**RE: Response to Comments, Bennoc Area NPDES OIL00159 Application for American Energy Corporation in Belmont County, Ohio**

Response to OEPA Comments from Bruce Goff and Eric Nygaard  
Dated 8/21/12, 8/15/12, 7/20/12, 7/13/12, and 7/11/12  
Bennoc NPDES Permit Application  
OIL00159

***Hydro-Chemical Analysis of Waste Water Discharge and Anti-Degradation Assessment: American Energy Corporation's Bennoc Coarse Coal Refuse Area Ponds 001 and 002***

Wheel treatment system – pictures provided by [www.chemstream.com](http://www.chemstream.com)

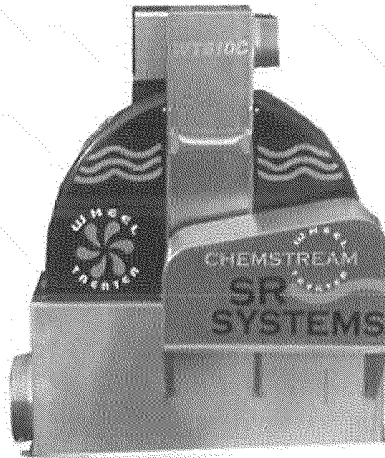
Comment: Do you happen to have any photos of the treatment ponds, the outlet structures, the chemical feed equipment and the discharge drainage ways (outlet ditches) you can share?

Response: We do not have any pictures of the proposed treatment ponds and their structures. However, we do have a picture (below) of the proposed wheel treatment system.
